ITEM 5. DEVELOPMENT APPLICATION: 57 ASHMORE STREET  
ERSKINEVILLE - BLOCKS B AND C

FILE NO: D/2017/681

## SUMMARY

Figure 28: Perspective of Block C, as viewed from the corner of Maddox Street and Mitchell Road, looking north-west. The red lines demonstrate how the frontage is broken up into three distinct elements, the blue arrows indicate the location of the full height breaks.

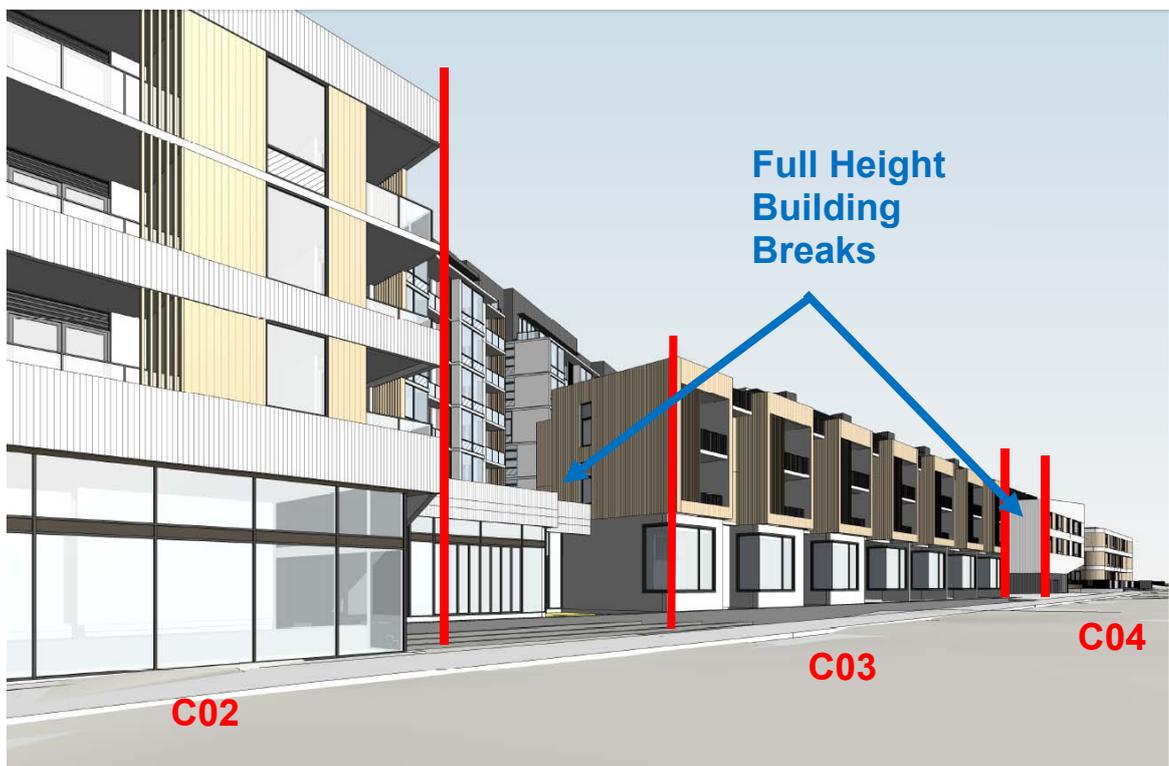
- (b) The design of Block C is to incorporate articulation or other design measures to reduce the impact of the 140m block length fronting Mitchell Road.

**Assessment:** The original Concept Approval included a long three storey Building C03 fronting Mitchell Road. The Detailed Proposal splits the longest built form on this frontage into two sections, and re-orientates the northern section to Stovemaker Lane as new Building C04. Furthermore, the re-organised frontage is further broken down into three distinct buildings (C02, C03, and C04) which incorporate distinct materiality and building expression, and are separated through recessed entries with full height breaks. This is illustrated in Figure 28 below.

Figure 31: 3D drawings illustrating the Detailed Proposal within the SLEP 2012 maximum height planes.

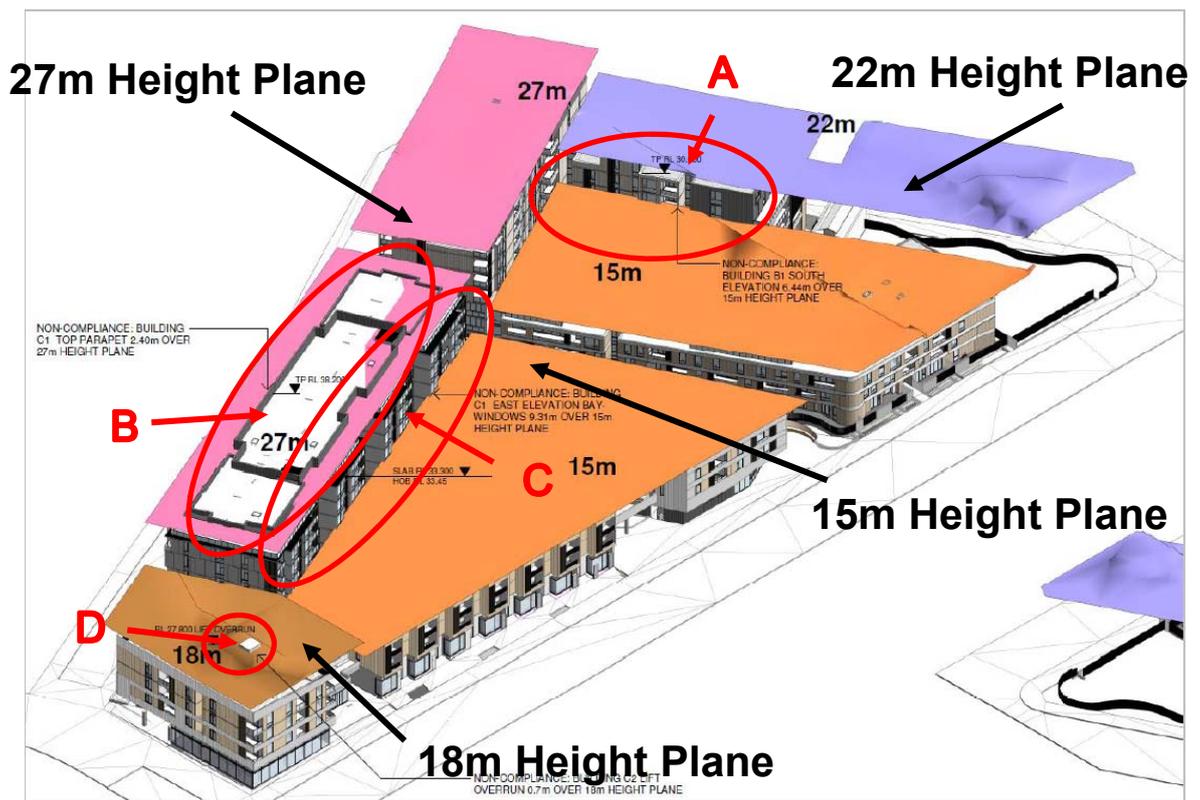
The proposed height of this building is 21.44m. This complies with the 22m maximum height plane within which it is principally located, however a small part of the southern face of the building protrudes into the adjoining 15m height plane. This results in a non-compliance of 6.44m above the 15m height plane, and a variance to the development standard of 42.9%. 7.86m<sup>2</sup> of GFA is accommodated on each floor within the non-compliant part of the building.

The proposed height of this building is 29.4m. This results in a non-compliance of 2.4m above the 27m height plane and a variance to the development standard of 8.9%.

The articulated facade of this building results in minor lateral protrusions into the 15m height plane on the eastern face of the building. This results in a non-compliance of 9.31m above the 15m height plane, and a variance to the development standard of 62.1%. 16.26m<sup>2</sup> of GFA is accommodated on each floor within the non-compliant part of the building.

A communal rooftop is proposed to be provided on this building. In order to provide equitable access, the lift overrun protrudes above the 18m height plane to a maximum height of 18.7m. This results in a non-compliance of 0.7m and a variance to the development standard of 3.9%. No GFA is contained within the non-compliant part of the building.

- (iv) The non-compliance arising on Building B01 (annotated A in Figure 31) facilitates an improved landscaped setback to Ashmore Street. This is achieved by pushing the building further south, into the site, resulting in the non-compliance. While the proposed variance is technically large (42.9%), in reality it is only a very small part of the building that is protruding into the adjoining height plane. While consideration could be given to deleting the non-compliant part of the building, this would have significant repercussions in terms of the internal layout of the floorplate. In the absence of any impacts arising from the non-compliance, such a request would be unreasonable. Accordingly, on balance, the proposal is considered superior to a compliant scheme, which would be less capable of simultaneously providing an acceptable setback and a rational floorplate.

- (v) The non-compliance on Level 8 of Building C01 (annotated B in Figure 31) facilitates the retention of the stand of Hill's Weeping Figs located in the north eastern corner of the site. This is, on balance, considered to be a better outcome for the site. In the absence of any impacts arising from the non-compliance, as detailed elsewhere in this report, a request to delete the non-compliant part of the building would be unreasonable.

- (vi) The non-compliance on the eastern face of Building C01 (annotated C in Figure 31) facilitates improved solar access to apartments by providing a 'pop-out' windows with glazing orientated to the north, as illustrated in Figure 32 below. If the facade was flattened in order to contain the building entirely within the 27m height plane, the affected apartments would no longer achieve two hours solar access at mid-winter, and overall solar access would fall well short of the minimum requirements of the ADG. While the proposed variance is technically large (62.1%), in reality it is only a very small part of the building that is protruding into the adjoining height plane. The proposed non-compliance is considered to result in an improved outcome for the site, and therefore a request to flatten the facade to contain it within the 27m height plane would be unreasonable.

- (vii) The non-compliance on the roof of Building C02 (annotated D in Figure 31) is to accommodate equitable access to the communal rooftop. The proposal results in no impacts to view corridors, does not contribute to overshadowing, and will not be visible from the public domain. If the proposal was amended to comply, equitable access to the communal rooftop may not be achieved. Accordingly, the proposed non-compliance is considered to result in an improved outcome for the site over a compliant scheme and therefore a request for strict compliance with the height standard would prevent the provision of equitable access to the rooftop and would be unreasonable.

Figure 33: Unmitigated non-compliant separation distances between apartments in Buildings B02 and C01, on opposing sides of Stovemaker Lane on the fifth to seventh storeys

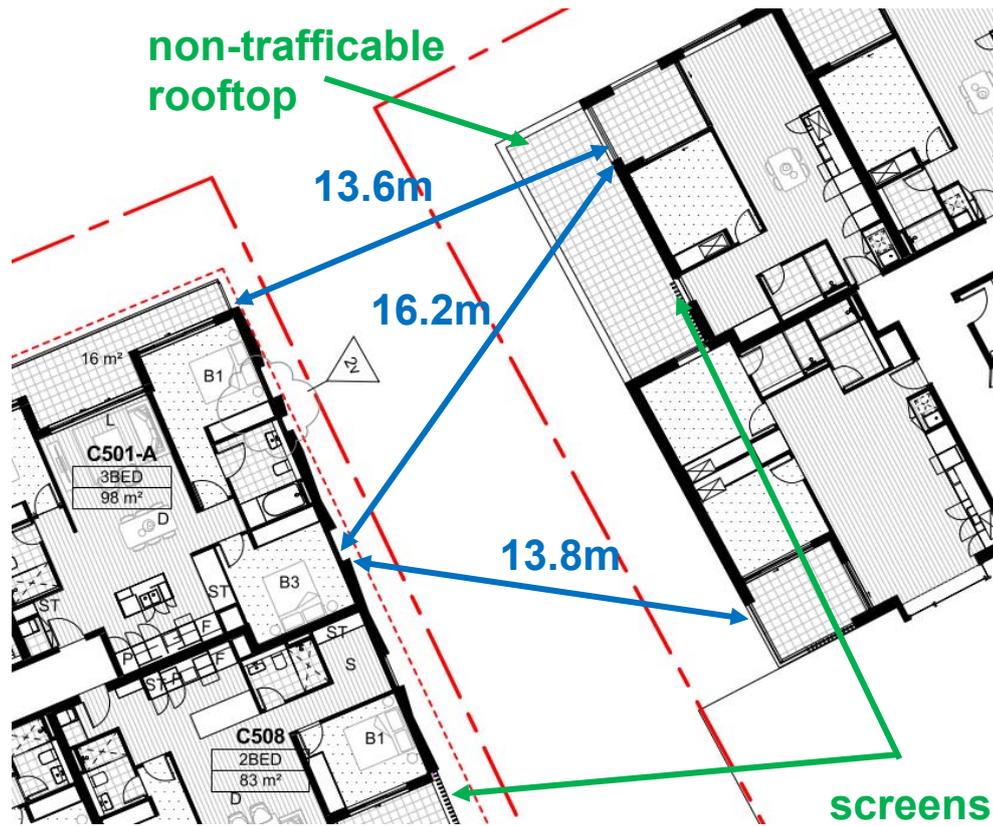
- (b) Separation distances between 12.2m and 14.8m (18m required) between balconies on either side of Stovemaker Lane in Buildings B02 and C01 on the eighth storey; and

- (c) separation distances between 8m and 10m between apartments in Building C01 and the communal rooftop on Building C02 (18m required).
79. These non-compliances are illustrated in Figures 33 to 35 below.

80. In order to ameliorate any privacy impacts arising from the non-compliance conditions of consent are recommended requiring the following design modifications:

Figure 36: Predicted noise levels on the building frontages, viewed from an elevated position above Maddox Street looking north-west

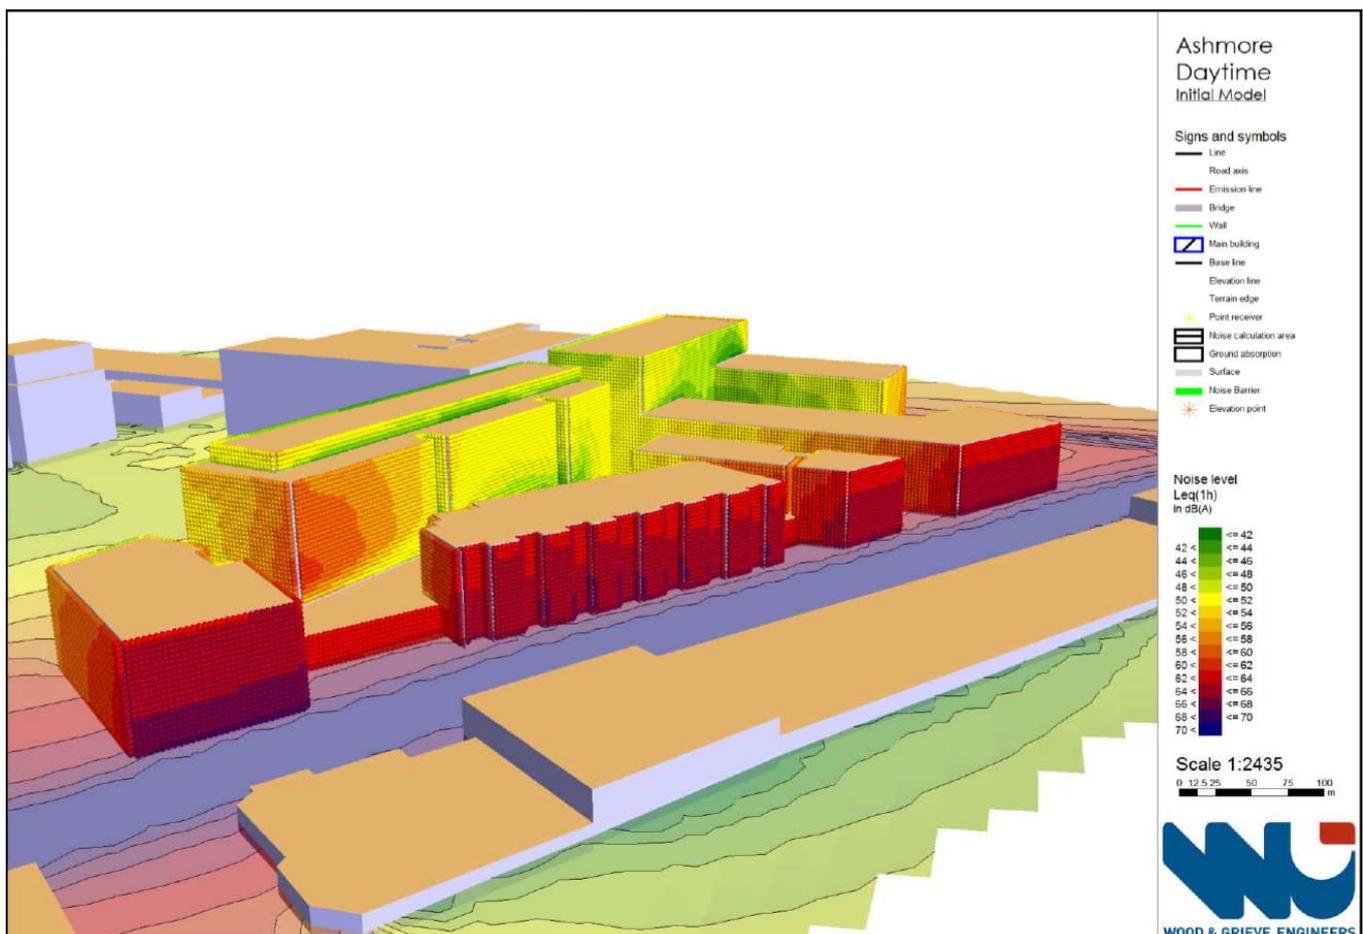
100. The ADG requires all habitable rooms to be capable of natural ventilation. In conjunction with this, internal noise criteria within habitable rooms must be met simultaneously. This is particularly challenging in noise affected environments.
101. The Acoustic Report submitted with the application identifies that apartments with exposure to Mitchell Road will not achieve compliance with the internal noise level criteria with windows open. An extract from the Acoustic Report that illustrates the predicted noise levels is provided in Figure 36 below.

102. In order to address this issue the applicant proposes that the affected apartments will rely on mechanical ventilation, however this is not supported because natural ventilation and compliance with the relevant acoustic criteria must be achieved simultaneously.

Figure 37: Apartment C715, located on Level 7 of Building C01, which is identified by the applicant as a 'local corner' apartment that is naturally cross ventilated

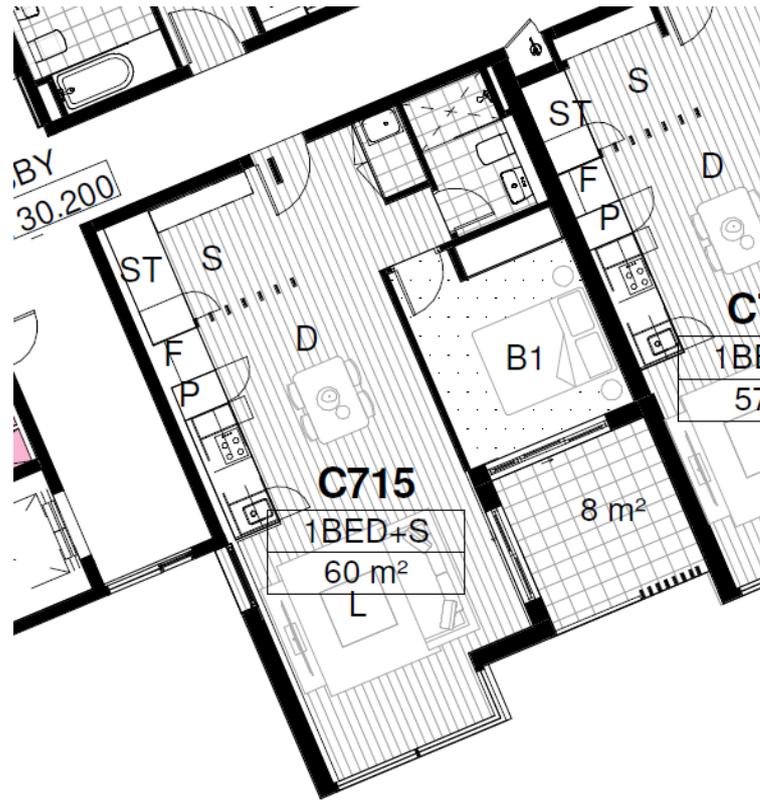
106. The submitted natural cross ventilation study claims 197 apartments (60%) are naturally cross ventilated.
107. City staff have reviewed the submitted documentation and have determined that the correct figure is 187 apartments (57%). This is because 10 apartments, identified in the submitted documentation as 'local corners', do not achieve natural cross ventilation. An example of one of these apartments is provided at Figure 37 below. The context of the wider building in which it is located is provided at Figure 38.

110. The application therefore seeks to expand the definition of dual aspect to include the ‘local corner’ apartment type. In order to test the efficacy of the ‘local corner’ in terms of achieving natural cross ventilation, the application was submitted for a third party peer review.

111. The review determined that the ‘local corner’ apartment type does not achieve natural cross ventilation. More specifically, Figure 39 below shows the likely pressures on the facade openings under various wind attack angles. The resulting range of attacked angles that is likely to produce the required pressure differentials between openings is shown on the simplified wind rose within each apartment, with wider coloured segments indicating broader ranges of cross ventilation.

Figure 39: Comparative analysis of a ‘local corner’ apartment and a dual aspect apartment as defined by the ADG

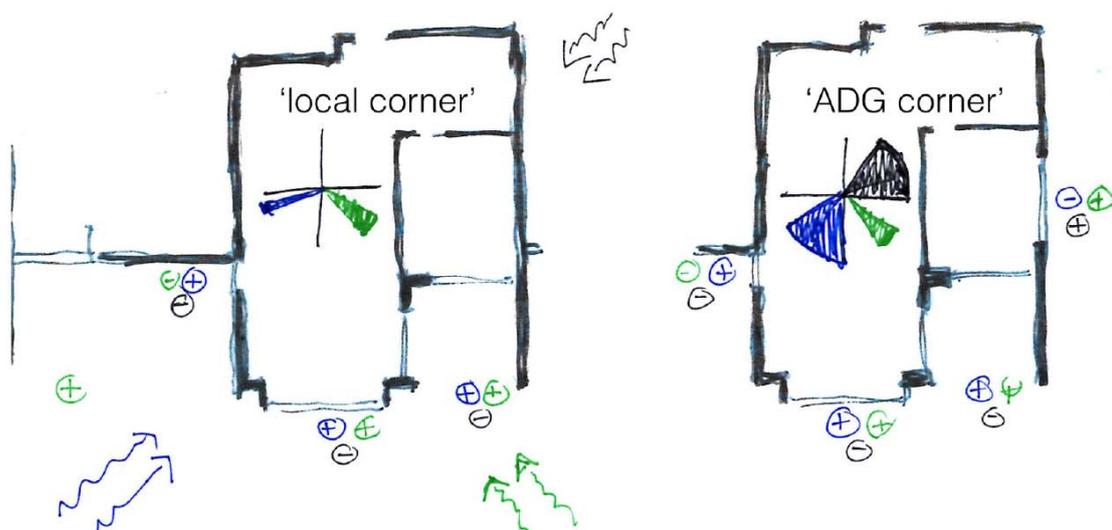
112. The third party review determined that a corner apartment will have a range of attack angles where openings are likely to experience significantly different pressures in the order of about 135 degrees (the green wind direction would not benefit a normal ADG corner type apartment). By contrast the proposed 'local corner' typology is estimated to have a range of wind attack angles with differential pressures of 45 degrees or less even when some benefit from an oblique wind is considered to be captured, which is not certain. Accordingly, the proposed 'local corner' arrangement is not likely to be equivalent to a corner apartment and should not be considered to be naturally cross ventilated.

Figure 41: Extract from the tree survey, illustrating the location of the proposed buildings of Block B in relation to the retained trees

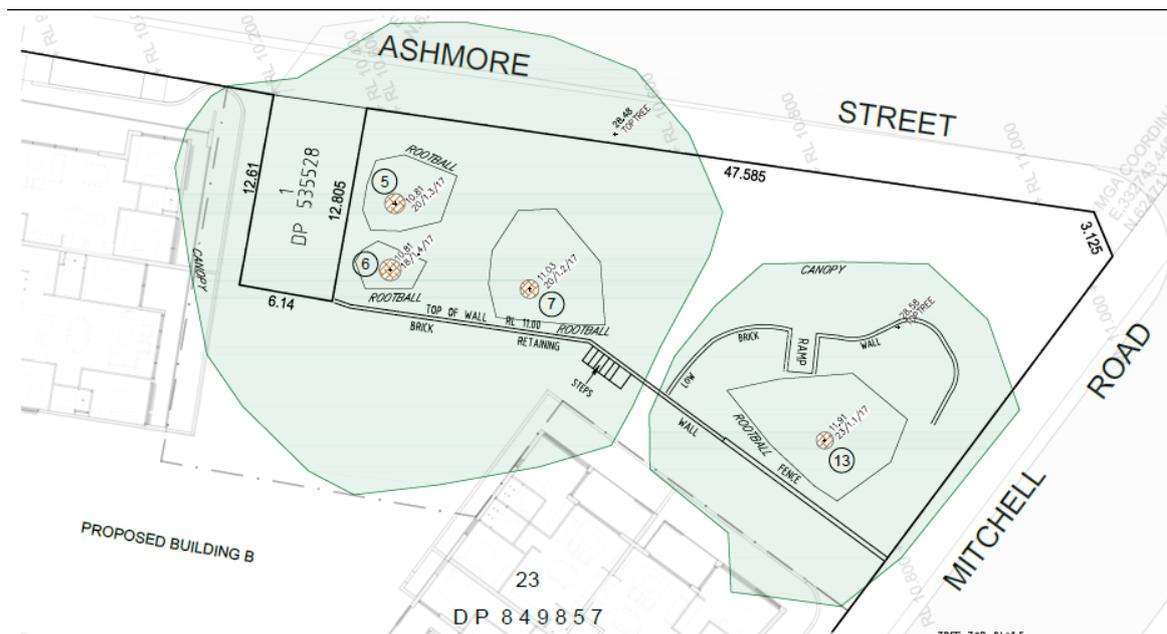
- (d) Two street trees on Mitchell Road are proposed to be removed due to poor health. The removal of only one tree is supported. The second tree has been assessed as having no issues, and therefore a condition of consent is recommended to ensure it is retained.
137. Further conditions of consent are recommended to ensure tree pruning is carried out in accordance with the City's requirements, and that other trees are adequately protected during the construction phase to ensure their long term viability.
138. A survey of the Hill's Weeping Fig Trees and an arborists report has been submitted with the application, which demonstrates that the proposal will not have an unacceptable impact upon the retained trees. An extract of the survey is provided at Figure 41 below.

139. Conditions are recommended to ensure the Hill's Weeping Figs are not adversely impacted by the proposed landscaping works in this location.
